IREDELL COUNTY HEALTH DEPARTMENT

IMPROVEMENT PERMIT / AUTHORIZATION TO CONSTRUCT / OPERATION PERMIT / EXISTING SYSTEM

SITE ADDRESS: 253 Cove Creek Ln. Mooresville, NC PHONE: ALT. PHONE: Kathleen 704 578-4951

SUBDIVISION: Chesapeake Pointe SECTION: III LOT # 44 LOT AREA: 2.18 Ac. DESIGN FLOW: 480gpd L.T.A.R.: .3

AS BUILT SKETCH

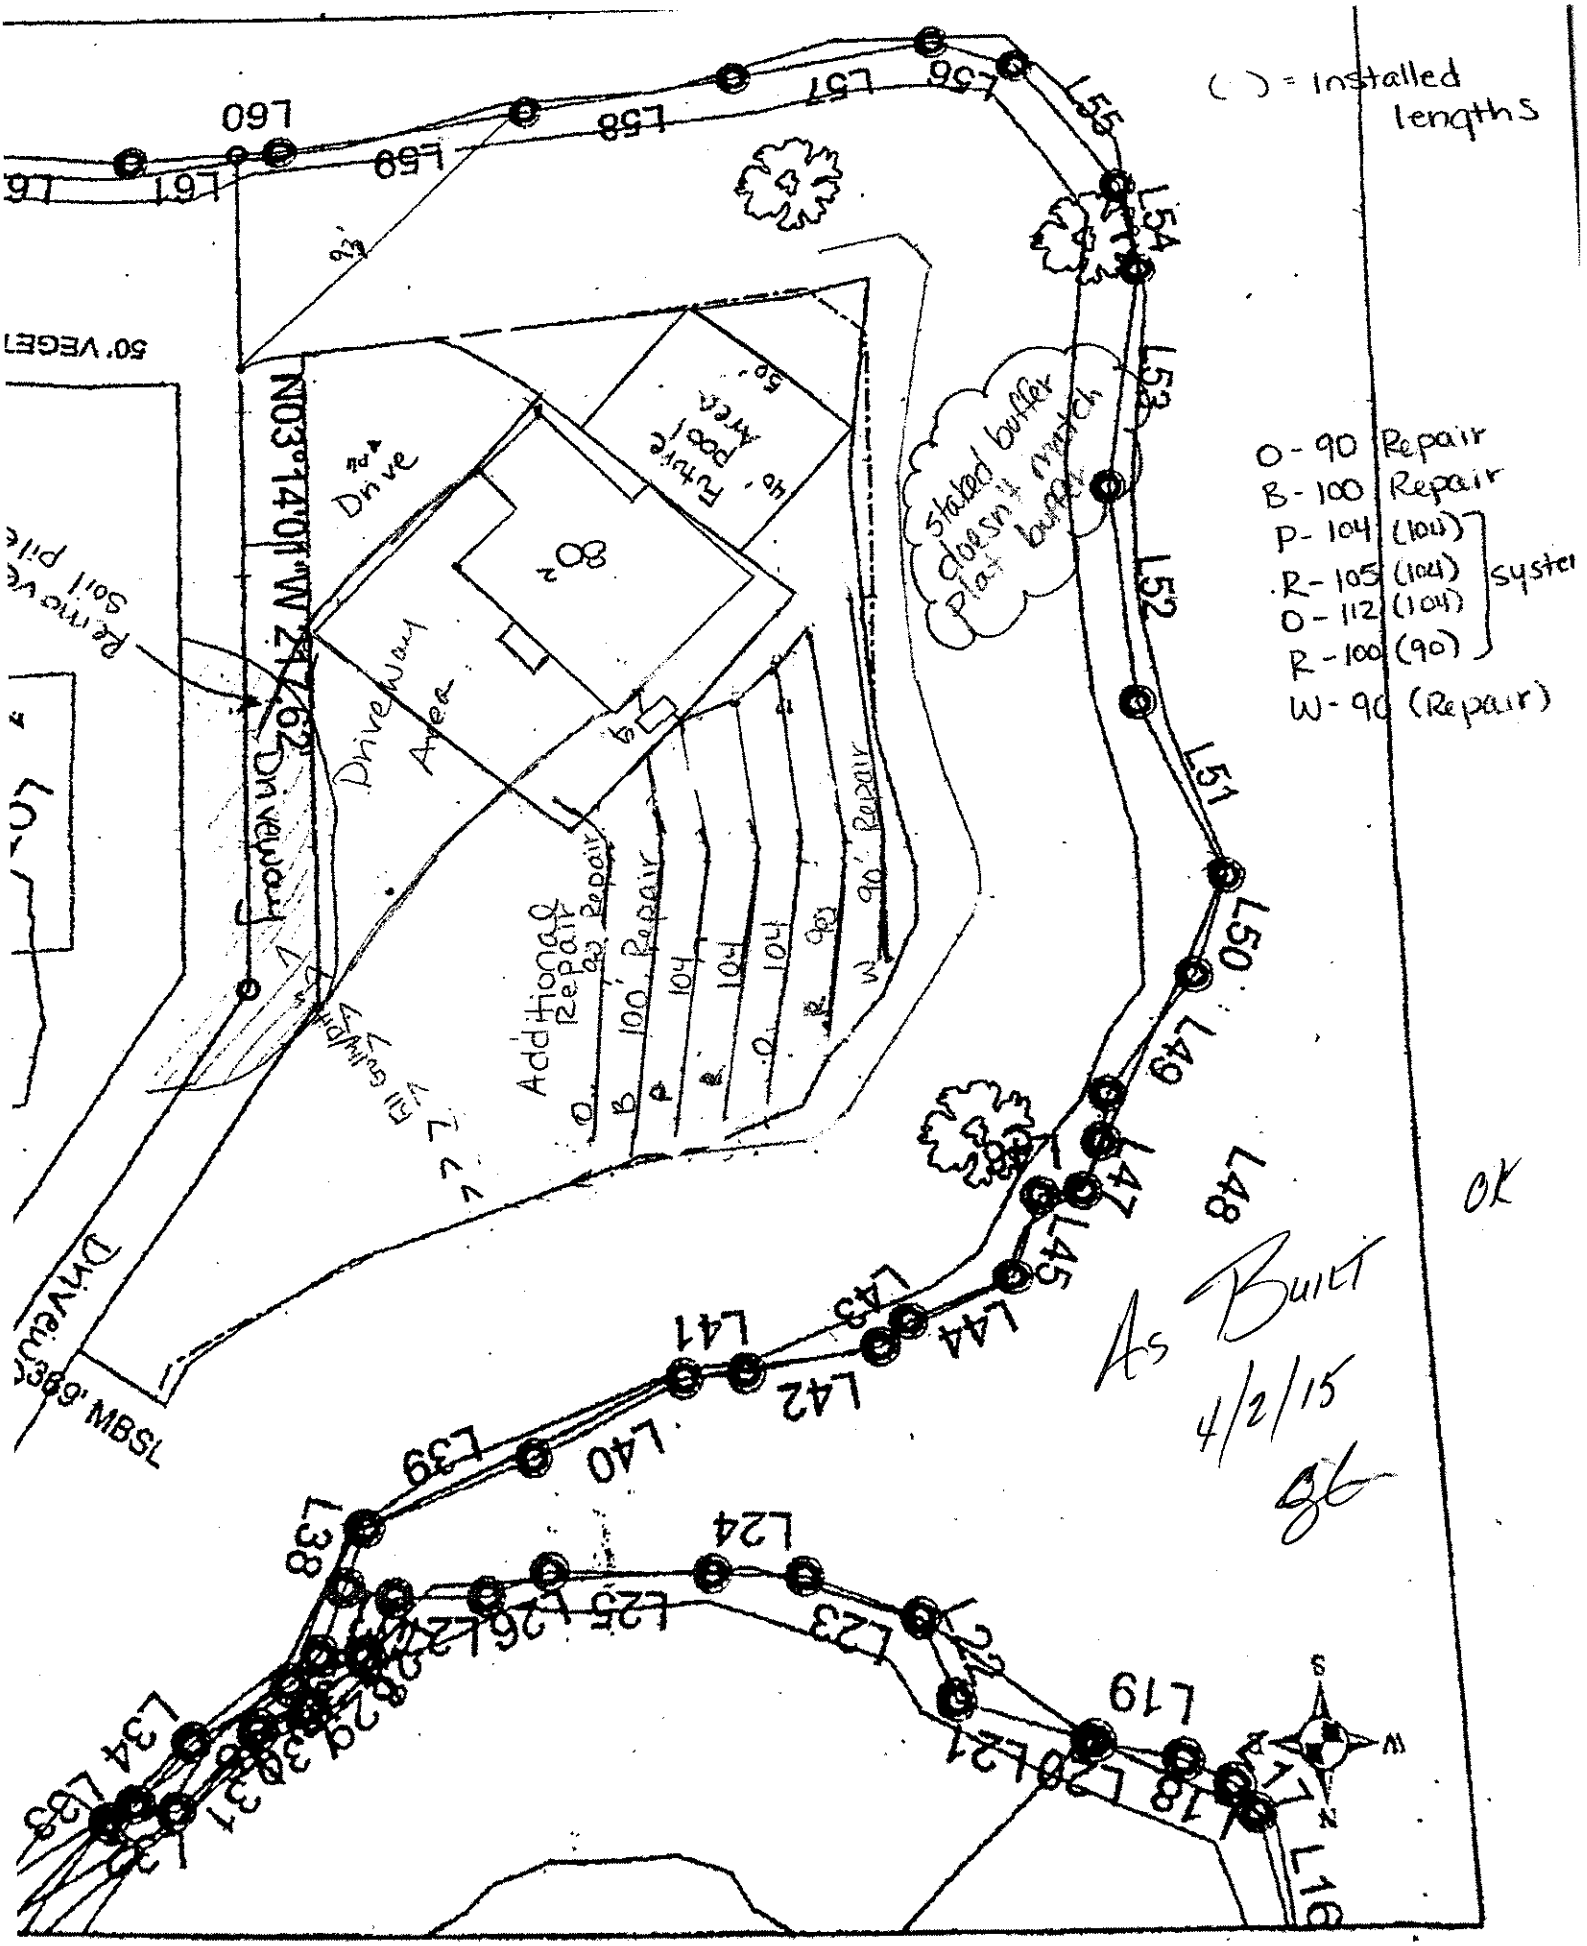
Comments / Conditions: *Note: Plumbing must be Stubbed out high in order for gravity flow to Septic Tank, Otherwise a "Pump" System will be required.

Plumbing Stubbed out Low. Tank Location was Moved To Accomodate Gravity System. Refer To As Built Submitted From The Oaks Group Dated 4/2/15. Additional Repair Available.
